**Re: Morningstar of Albuquerque
Request for Certificate of Occupancy- Transportation Development**
D.R.B. Stamp dated 10-21-14 (D19-D029)
Certification dated 11-17-15

Project: MorningStar of Albuquerque
8051 Palomas Ave., NE

Subject: TCL Certification

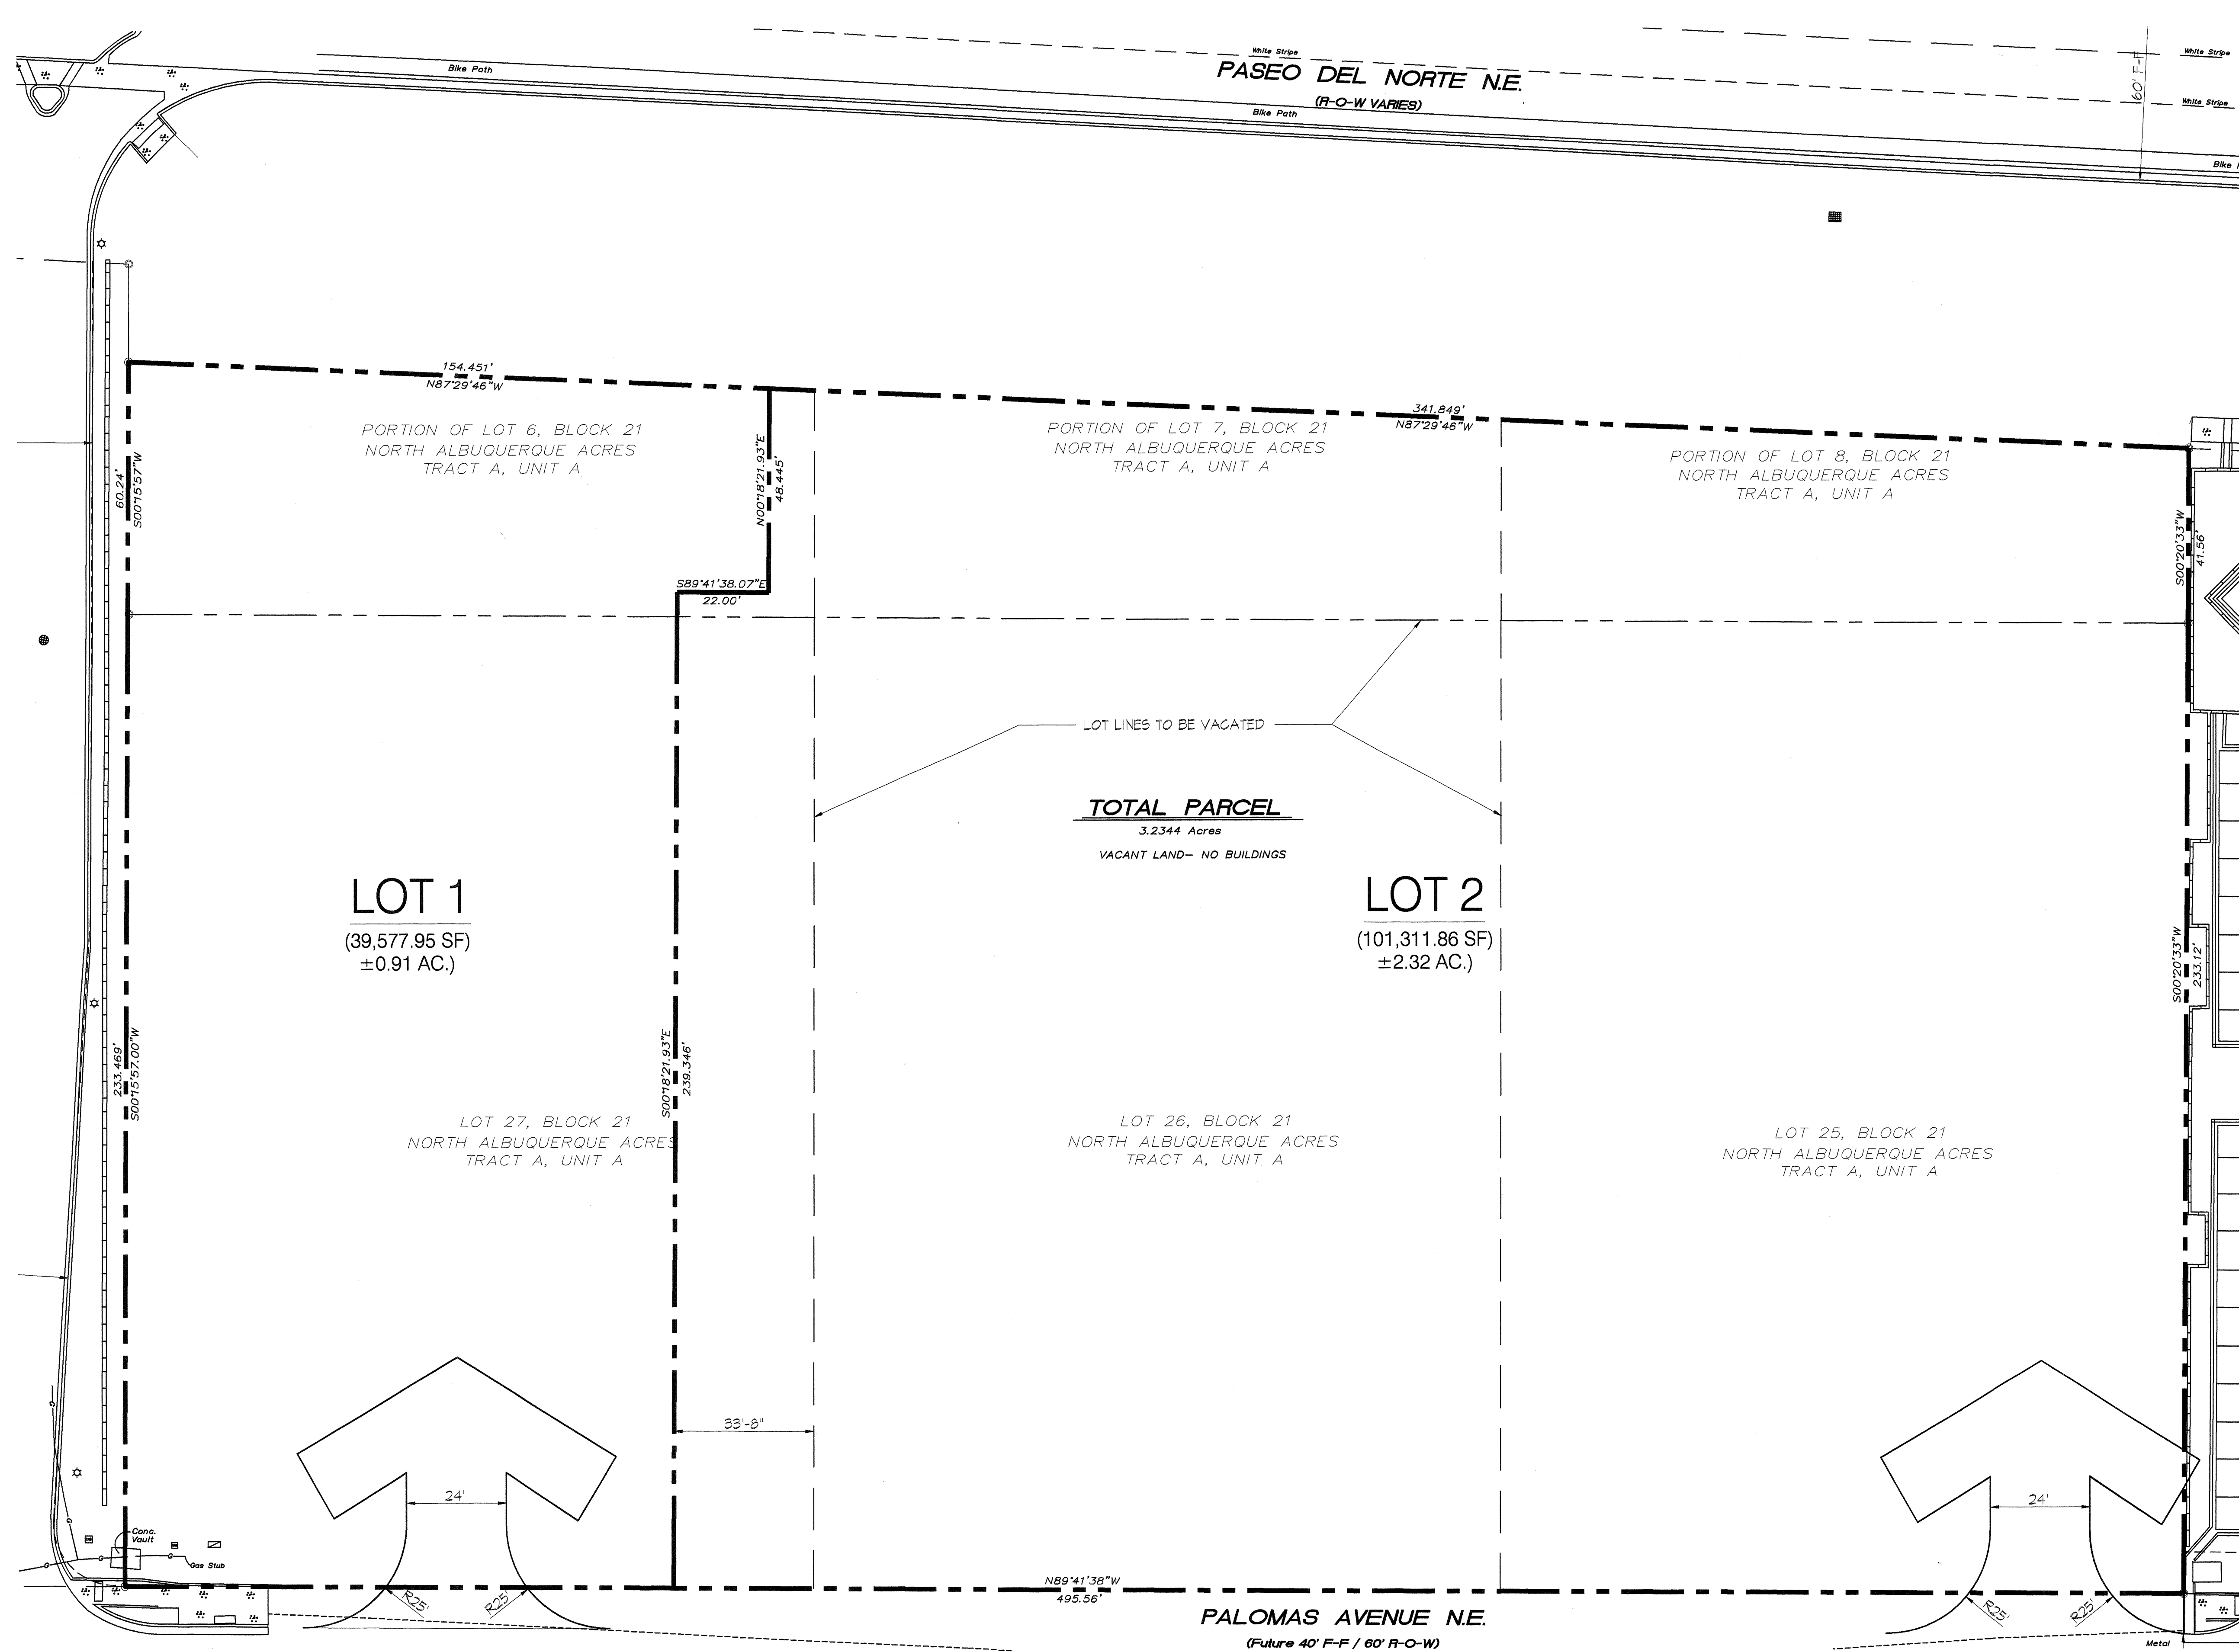
Areas of modification:

1. The temporary PCC sidewalk between the NW corner of the building and the construction/administration trailer to the west will be removed on Nov. 27th and is not part of this certification.
